# LiDAR Quality Assessment Report

CA\_OrangeCo\_2011

The primary purpose of this project was to develop a consistent and accurate surface elevation dataset derived from high-accuracy Light Detection and Ranging (LiDAR) technology for the USGS FEMA IX Orange County, California Project Area.

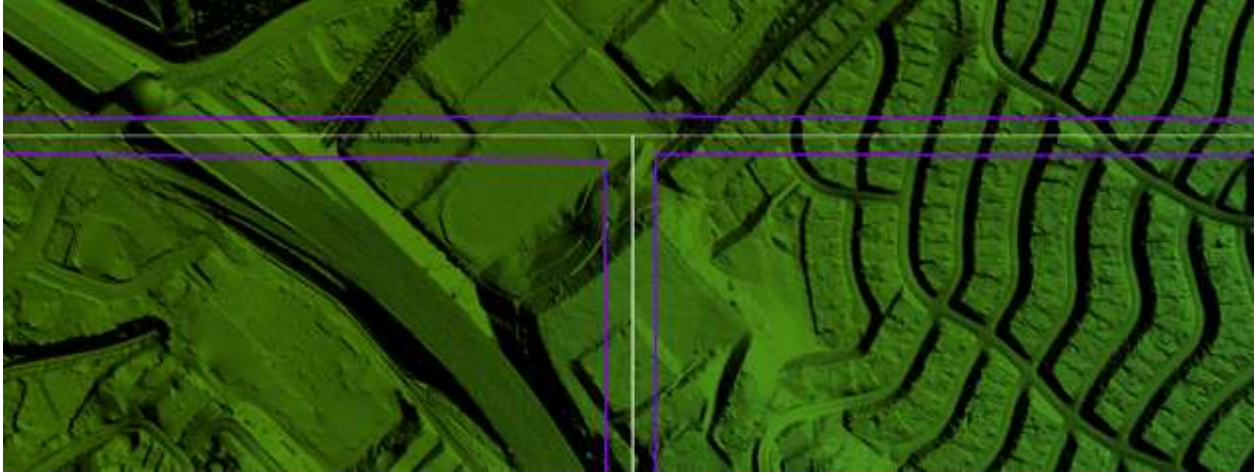
Reviewer identified a minimum of 3 waterbodies greater than 2 acres not hydroflattened. These errors are documented in a shapefile created by the reviewer at NGTOC named errors.shp. In the pdf, "Dewberry Response to USGS Review Orange County 10012012" Dewberry explains that one of four calls regarding breaklines/waterbodies was incorrect, from viewing the intensity images it can be determined that no water existed at the time of acquisition. The other three calls were addressed, corrected, and new DEM and LAS files were redelivered to the reviewer via ftp site on 10/02/12. Reviewer visually inspected the redelivered DEMs and found them acceptable.

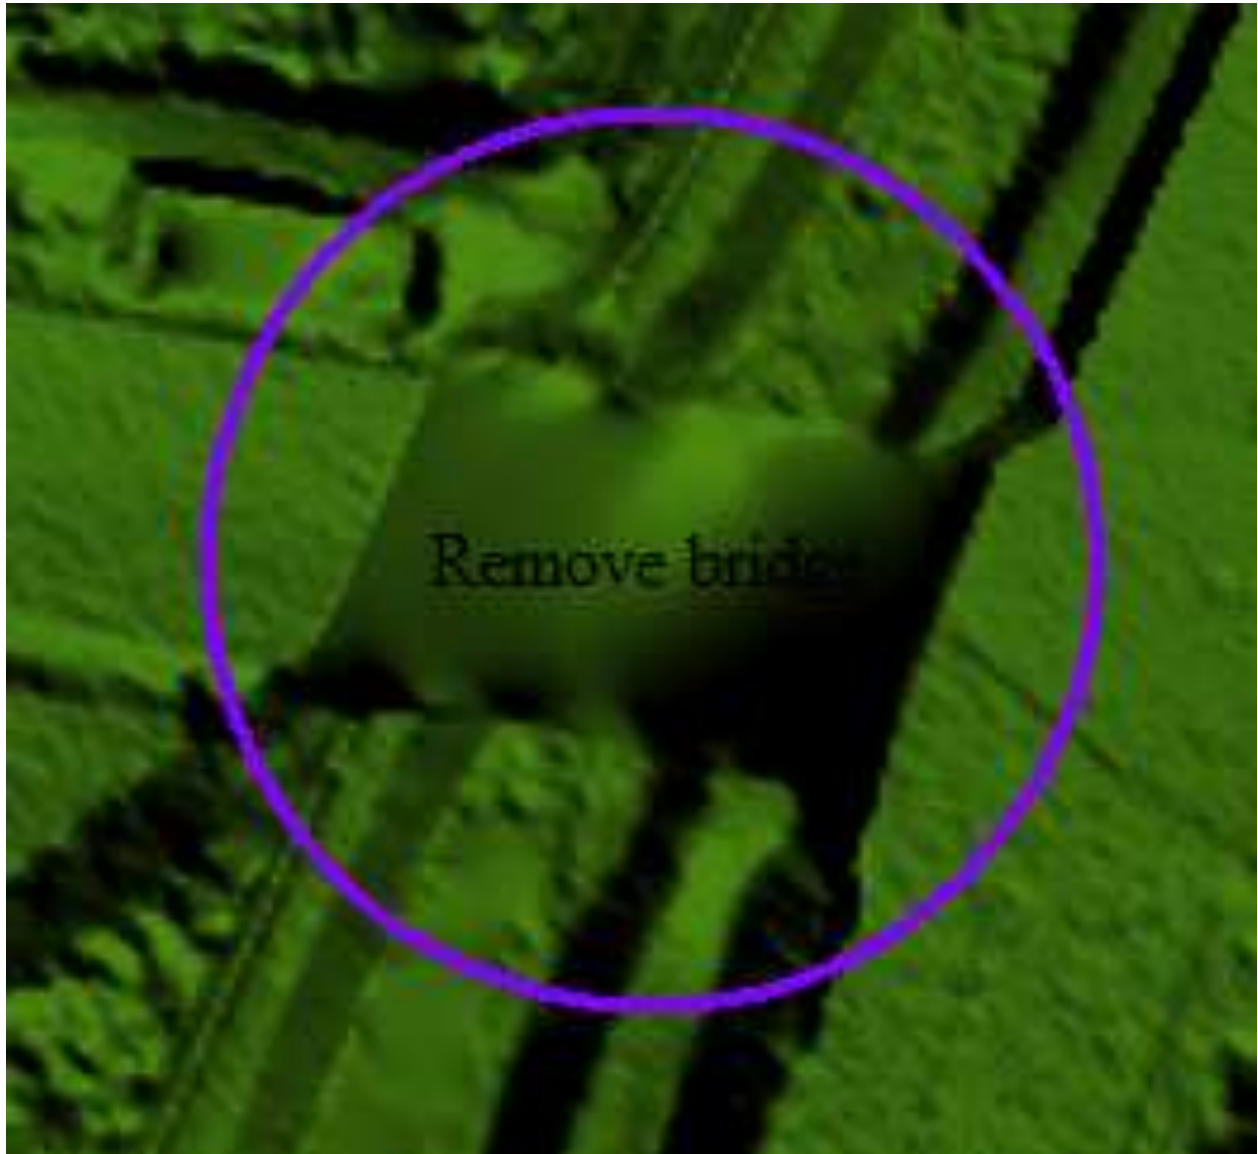
Reviewer identified bridges remaining in bare earth surface. These errors are documented in a shapefile created by the reviewer at NGTOC named errors.shp. See following image and comments for updated information.

In the pdf, "Dewberry Response to USGS Review Orange County 10012012" Dewberry explains that these were originally believed to be culverts, but have been removed from the bare earth surface, DEMs were redelivered to reviewer via ftp site on 10/02/12. Reviewer visually inspected the redelivered DEMs and found them acceptable.

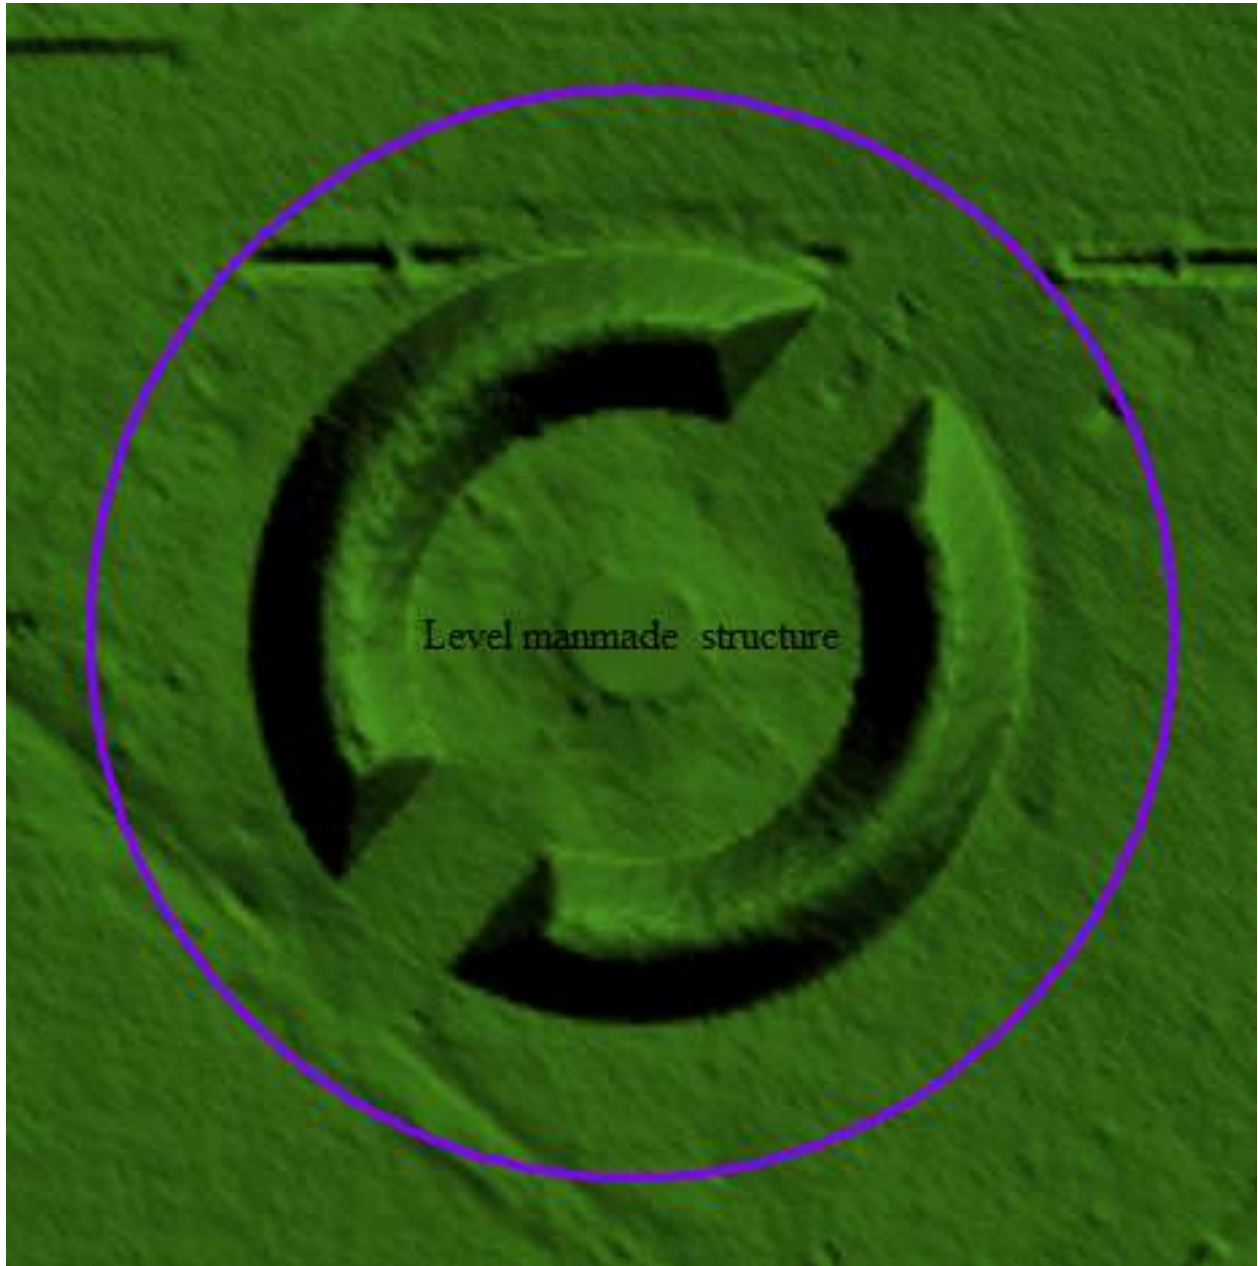
Reviewer identified a man-made structure in bare earth surface. This error is documented in a shapefile created by the reviewer at NGTOC named errors.shp. In the pdf, "Dewberry Response to USGS Review Orange County 10012012" Dewberry explains that in this instance earthen mounds have been formed around the feature and have been correctly included in the ground classification. Reviewer accepts this response.

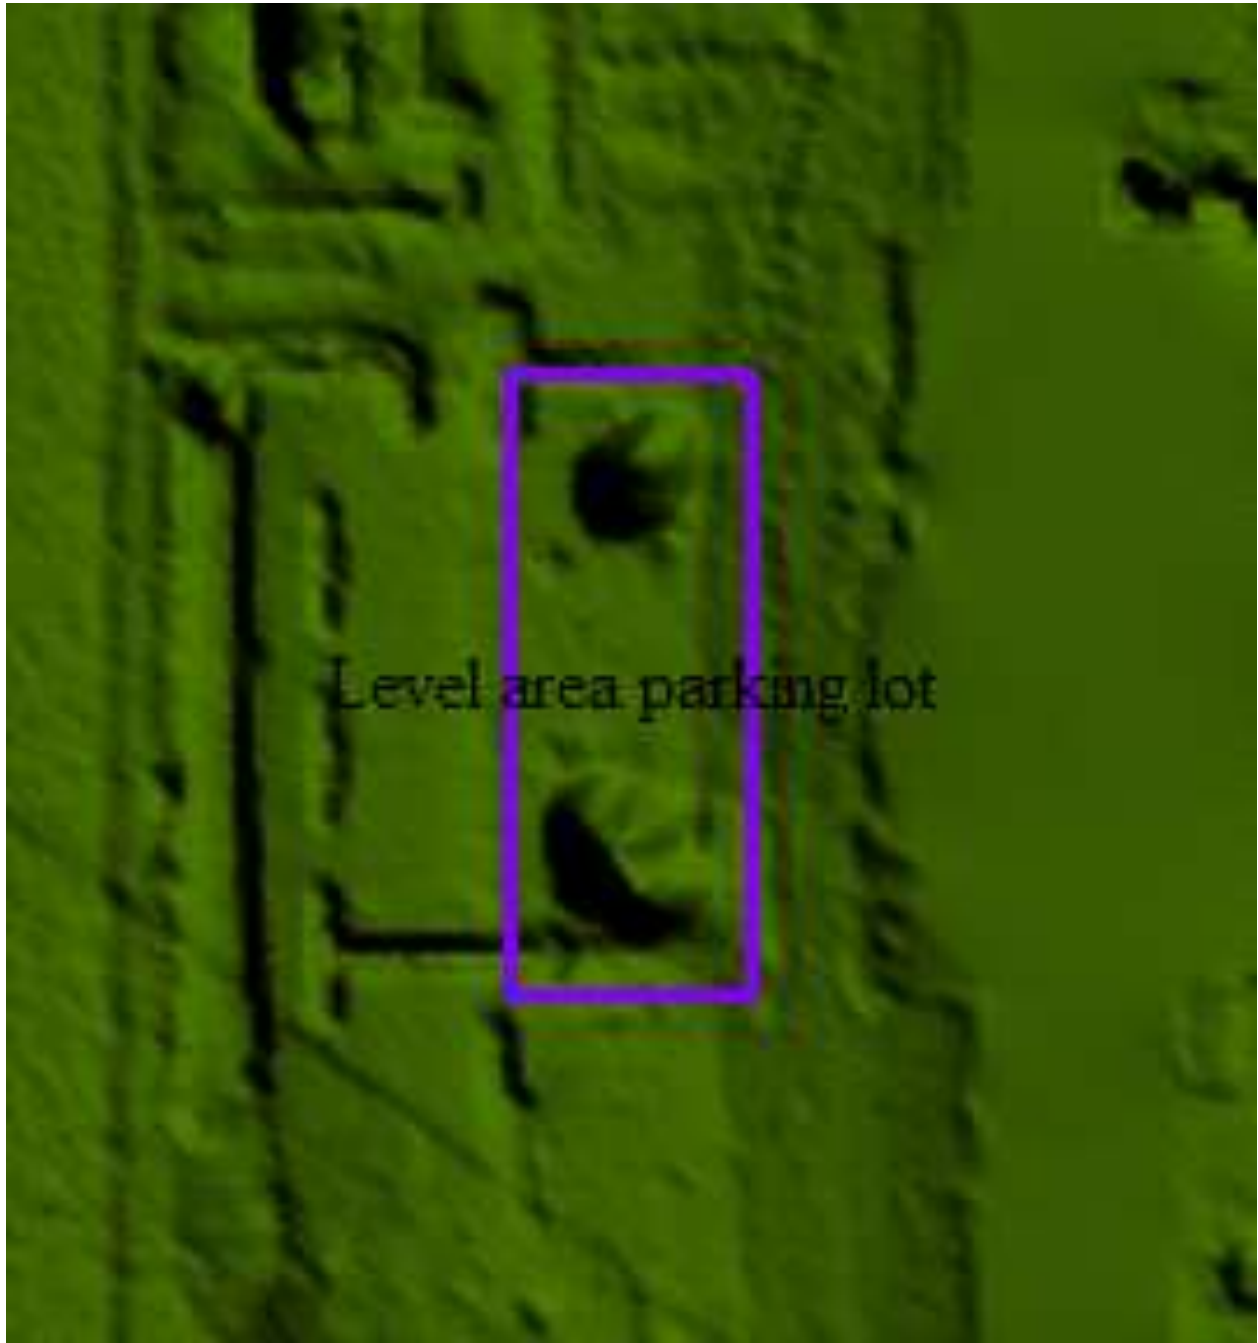
Reviewer identified areas of extreme elevation change within man-made parking lot that needs further removal. This error is documented in a shapefile created by the reviewer at NGTOC named errors.shp.

In the pdf, "Dewberry Response to USGS Review Orange County 10012012" Dewberry notes that such artifacts have been removed, DEMs redelivered on 10/02/2012. Reviewer visually inspected redelivered DEMs and found them acceptable.
